SUBJECT: CERTIFIED MINUTES OF THE ACRS ADVANCED BOILING
 WATER REACTOR SUBCOMMITTEE MEETING ON APRIL 9,
 2014

**ADVISORY COMMITTEE ON REACTOR SAFEGUARDS
 MINUTES OF THE ABWR SUBCOMMITTEE MEETING ON APRIL 9, 2014**

The purpose of the meeting was to review Section 2.5S, “Geology, Seismology, and Geotechnical Engineering,” of the Combined License Application (COLA) submitted by the Nuclear Innovation North America (NINA) for South Texas Project (STP) Units 3 and 4, and the

Growth Fault near STP site

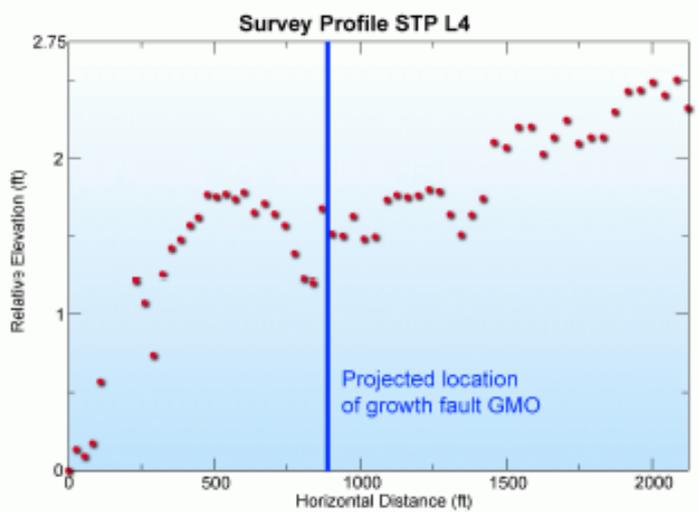
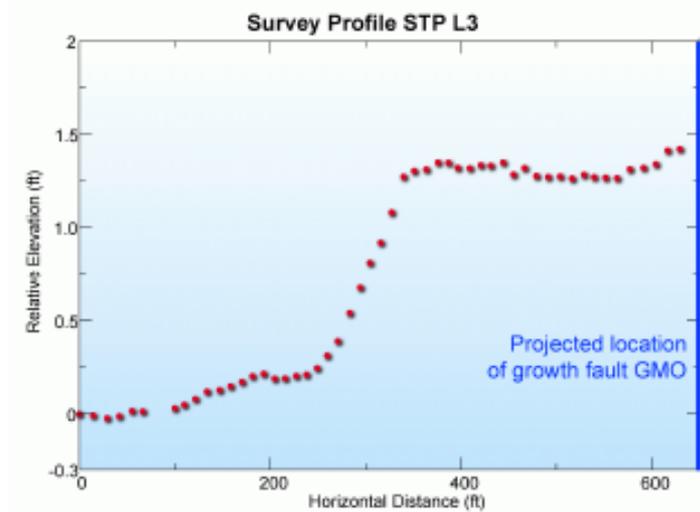
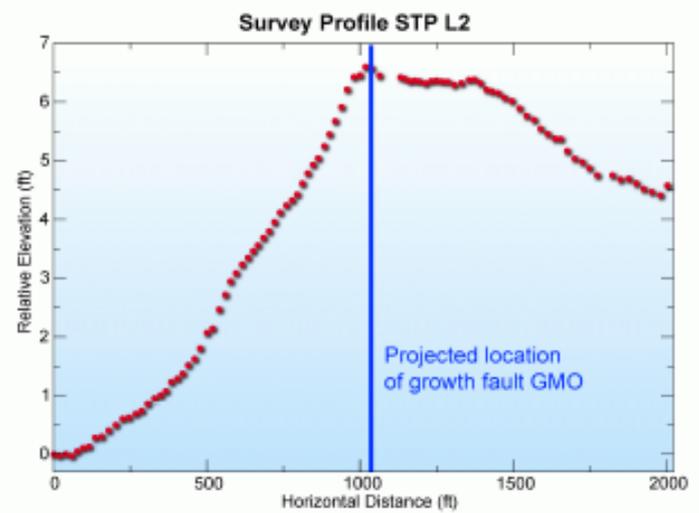
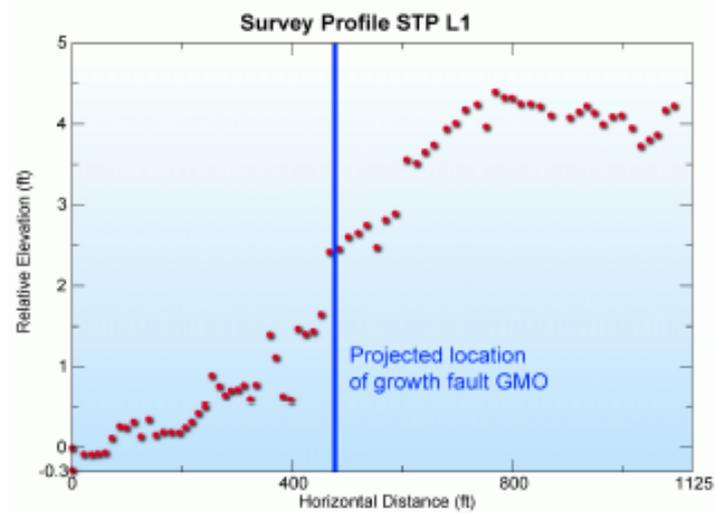
2 MR. LI: Okay, next please. This is the
3 concern from ACRS regarding the growth fault at the STP
4 site. Basically the item, I'll read it here.
5 Basically it's in case the, would high-resolution
6 shallow zone seismic reflection profiling using
7 appropriate apertures, detail and the best available
8 techniques provide useful information on the presence
9 and nature of the growth faults at the STP 3 & 4
10 construction zone and in the vicinity of the main
11 cooling reservoir where the GMO and the GMP faults were
12 found?

19 MR. HINZE: Those reflections lines on 1,
20 and for 1 and 2, did they show the position of GMP and
21 GMO?

17 MR. HINZE: Okay, what we're trying to do
18 is determine, ascertain whether a seismic reflection
19 can map the growth faults to near the surface, to the
20 surface. And that's what this is about, and that's
21 what my line of questioning was.

20 MR. HINZE: My satisfaction is that the
21 RAI that has been proposed is satisfactory for the
22 safety purposes of this site. That's the bottom line.
23 I mean putting it into the context of the nuclear power
24 plant, that's where we're at.

- Boring indicates subsurface stratigraphic continuity for the entire site.
- Units 1 and 2 foundation excavation detected no growth faults
- Since Units 1 and 2 construction, no observation of any abnormal topographic changes at the site
- Surface infrastructures associated with Units 1 and 2 indicate no recent surface deformation
- Embankment for the MCR indicates no surface deformation

Summary of Applicant's Seismic Hazard Reevaluation (Cont'd)

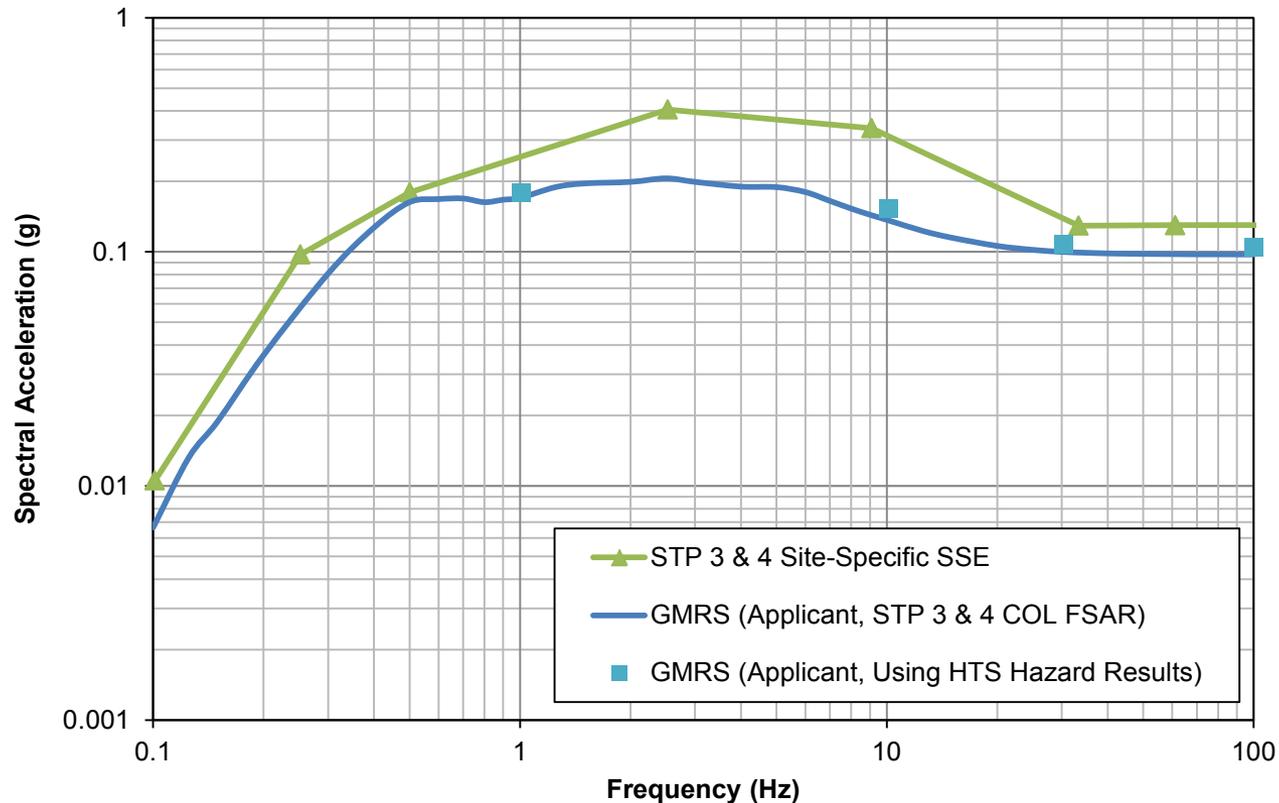
Mr. Head discussed how NINA addressed the Fukushima Recommendation 2.1, the CEUS report, and reevaluated the seismic hazard by doing the probabilistic seismic hazard analysis (PSHA). Member Stetkar asked if the uncertainties in the FSAR seismic hazard curves are appropriately accounted for in that the uncertainties should be higher at higher accelerations. STP seismic hazard curves show modest uncertainty and not an increasing uncertainty at higher accelerations. He	P12-33, 37, 43 NINA Slides 8, 9

<p>was concerned that the STP 3&4 GMRS curve may not be correctly calculated. Same trend was noted in hazard curves in NUREG 2115. A long discussion followed, and this was taken as an action item for future follow up.</p>	
<p>Consultant Hinze noted in FSER Table 2.5.2-3, "Updated Maximum Magnitude (Mmax) Distributions (mb) for the Gulf Coast Seismic Source Zones," the Technical Integrator's spread of seismic hazards in the Gulf Coast seismic zone was modified to final values less than the TI team's magnitudes. Mr. Head noted, that was the consensus of the SSHAC probabilistic process, which resulted in curves with less than three percent difference at the maximum.</p>	<p>P29-33, 36-37</p>
<p>Consultant Hinze noted that Section 8 of NUREG 2115 prohibits use of the test site calculations for design or analysis of any engineered facility. Mr. Head stated that the information from the test site was used as a confirmatory assessment and not as part of any design analysis.</p>	<p>P33-36</p>

17 And that's contrary to what the individual
18 expert curves show. The individual expert curves do
19 show an increasing divergence as you go to higher
20 accelerations, which means the experts disagree more,
21 if you will, which ought to affect the uncertainty.

6 MEMBER STETKAR: Thank you. The red dots
7 are actually derived from the Houston test site or
8 whatever you want to call it in NUREG 2115. I've
9 absolutely the same comment about the hazard curves in
10 NUREG 2115. Those uncertainties don't increase. So
11 there's something fundamental about the way people are
12 doing these things.

- Applicant concluded that STP COL application GMRS did not need to be revised:
 - The CEUS-SSC STP GMRS (blue squares) is very close to, and not significantly above, the STP COL application GMRS (blue curve), while the site-specific SSE (green curve) envelopes both
